Office Action Summary	Application No. 10/759,102	Applicant(s) MIWA, KAZUYA	
	Examiner Raymond Alejandro	Art Unit 1745

DETAILED ACTION

FIG. 6

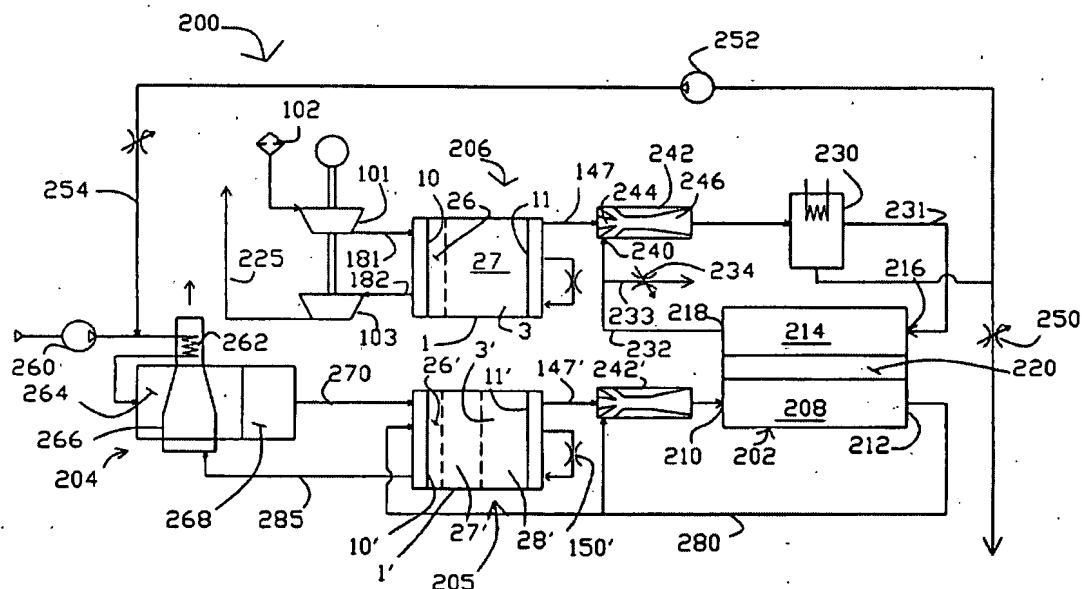
Keefer et al disclose a system and process for providing hydrogen to fuel cells (TITLE/Abstract) including a steam reforming fuel processor 204, a fuel cell 202, and a hydrogen purification PSA system 205 (*PSA stands for pressure swing adsorption*) (P0096/CLAIM 18). Reforming is used to generate hydrogen (P0004, 0103), and the fuel cell provides a source of electrical current (P0003). It is evident from **Figure 6** below that the hydrogen purification PSA system 205 is both upstream and downstream of the fuel cell 202 (See FIGURE 6). *Thus, it also receives the anode exhaust of the fuel cell.* **FIGURES 7-9** also depict other fuel cell power plant systems. Keefer et al disclose substitution or combined use of any type of hydrogen purification unit such as gas separation devices including other types of adsorption modules or gas membrane separation systems (P0095 & 0005).
